Virgil C. Summer Nuclear Station (VCSNS) Units 2 and 3
Combined License Nos. NPF-93 and NPF-94
Docket Nos. 52-027 & 52-028

Subject: VCSNS Units 2 & 3 LAR 14-14 R3 S1: Supplement 1 to Revision 3 of
Request for License Amendment: Structural Design of Auxiliary Building
Floors

**Responses to NRC Staff Questions Regarding LAR 14-14 R3
(LAR 14-14 R3 S1)**

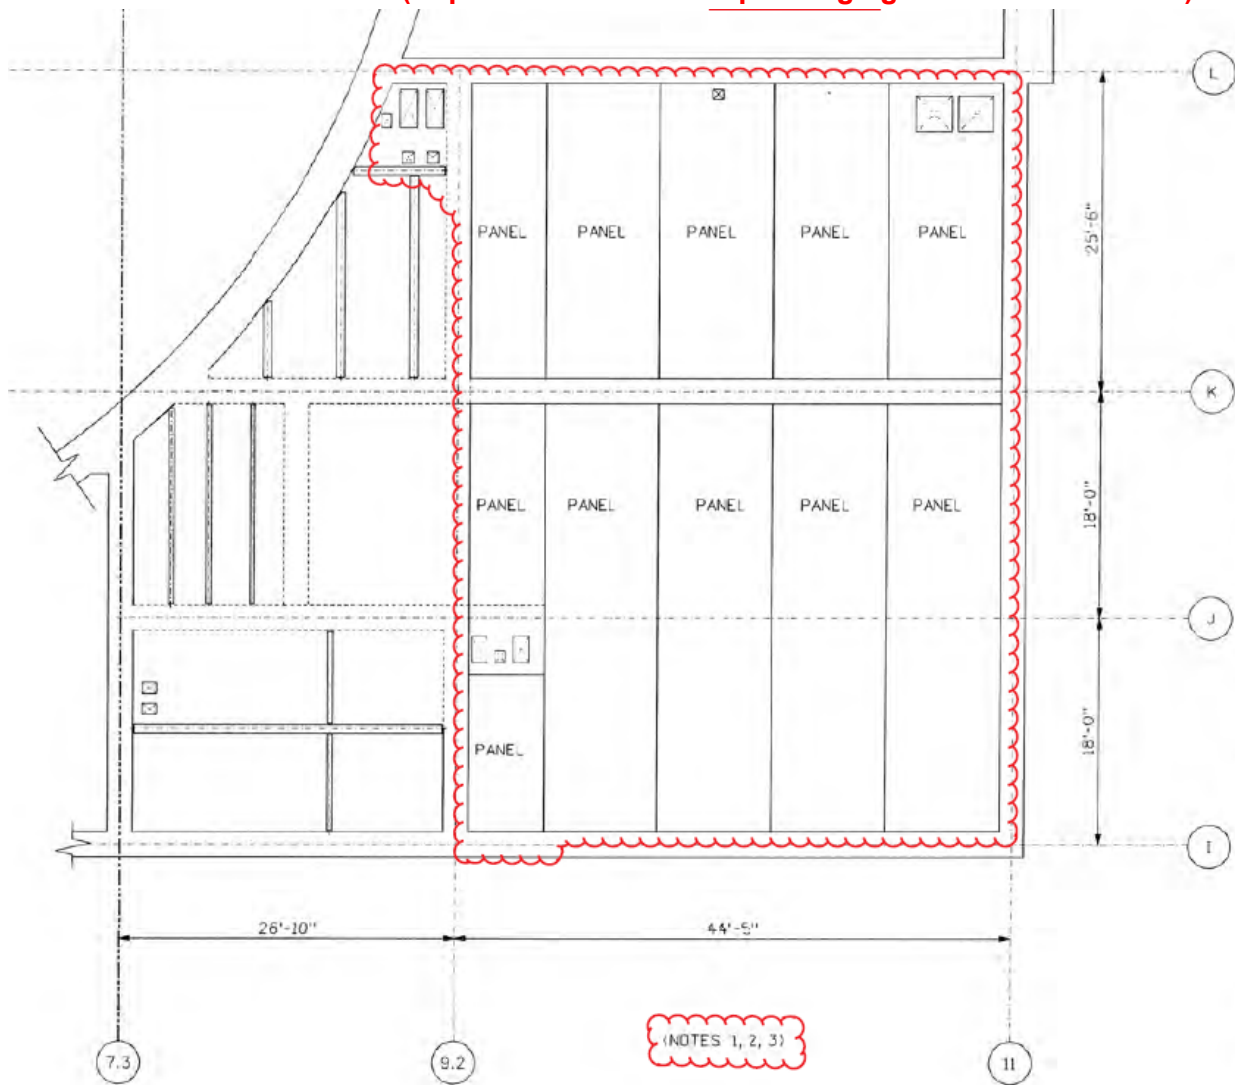
- Add identification of applicability of Note 15 on the bottom of Figure 3H.5-9, Sheet 2.
- Add identification of applicability of Notes 1, 13, and 16 on the bottom of Figure 3H.5-9, Sheet 3.

In addition, Figure 3H.5-9, Sheet 2, is revised to remove an unintended change to the depth of the fins inadvertently included with the previous revision. The fins are again identified on the figure as 9 inches in depth.

UFSAR Figure 3H.5-9 (Sheet 1 of 3), Auxiliary Building Finned Floor – Revise the information to add the Notes shown below.

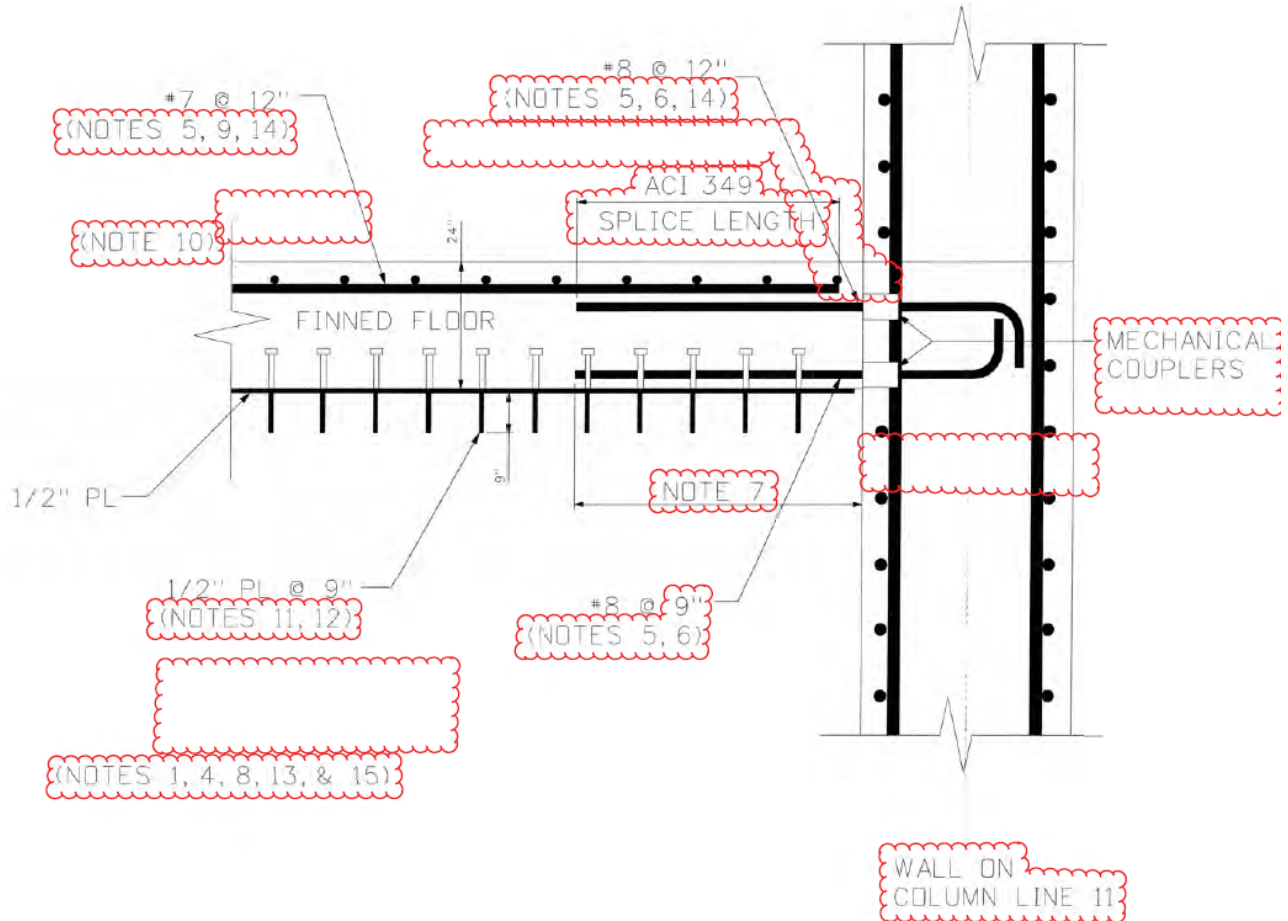
UFSAR Figure 3H.5-9 initially implied that those areas that had finned floors included ½ inch of steel at the bottom of the finned floors. However, in the LAR, the licensee adds Note 1 to Figure 3H.5-9. Note 1 indicates that the details shown in the figure are specific to the floor at elevation 135'-3" (main control room ceiling). In addition, in the LAR the licensee revised UFSAR Section 3H.5.4 which now specifies that Figure 3H.5-9 shows the finned floor above the main control room only, (instead of the figure applying to all of the finned floors). Therefore, it is no longer clear if the ceiling below the main control room will still include ½ inch of steel. The ½ inch of steel provides additional shielding for the main control room. In a departure in the Levy application, the staff relied on this steel thickness to reach their safety finding that the design met the requirements of GDC 19. Summer and Vogtle are expected to make a similar change in a future LAR. Please clarify that the thickness is still ½ inch or provide an evaluation for a change (If the new thickness is less than ½ inch, the licensee should evaluate the effects of this change on the dose inside the main control room). In addition, please clarify that the change to this Tier 2* information will remain Tier 2*, i.e., information in Figure 3H.5-9 specifying the steel thickness for the ceiling below the main control room remains Tier 2*.

Please note that in addition to adding Note 16 on Figure 3H.5-9, Sheet 1, the following notes are also identified on corresponding sheets of Figure 3H.5-9 for clarification purposes:

As indicated, the added Note 1 for Figure 3H.5-9 does indicate that the details shown in the figure are specific to the floor at elevation 135'-3" (MCR ceiling). However, Note 1 also indicates that the reader should "Refer to this and other notes for additional information about design details for other floor sections and for connections to other walls." Per UFSAR Subsection 3H.5.4, Figure 3H.5-9 is still the typical figure of finned floors. In particular, Note 8 addresses "Additional bottom layer reinforcing steel" for the finned floors at elevation 117'-6" indicating that the figure does apply to other floor sections. The design information on Figure 3H.5-9, Sheet 3, is applicable to all finned floors. For clarification purposes, Note 16 is added to Figure 3H.5-9 with the statement of "The design information shown on Sheet 3 is applicable to finned floors for locations away from

openings, penetrations, embedments, and other obstructions.” Thus, the licensing basis still requires ½” steel plates at the bottom of finned floors on elevation 117'-6" (ceiling below the MCR).

As indicated above, the Tier 2* Figure 3H.5-9 and associated notes, address the ceiling below the MCR and the Tier 2* information remains Tier 2*, and is not impacted by the LAR.

An updated (revised) markup of Figure 3H.5-9 (Sheets 1, 2 and 3) is included within this enclosure. The revised figure replaces the previously provided markups of this figure.

15. THE SHEAR STUD DESIGN SHOWN IS FOR LOCATIONS AWAY FROM OPENINGS, PENETRATIONS, EMBEDMENTS, AND OTHER OBSTRUCTIONS.
16. THE DESIGN INFORMATION SHOWN ON SHEET 3 IS APPLICABLE TO FINNED FLOORS FOR LOCATIONS AWAY FROM OPENINGS, PENETRATIONS, EMBEDMENTS, AND OTHER OBSTRUCTIONS.
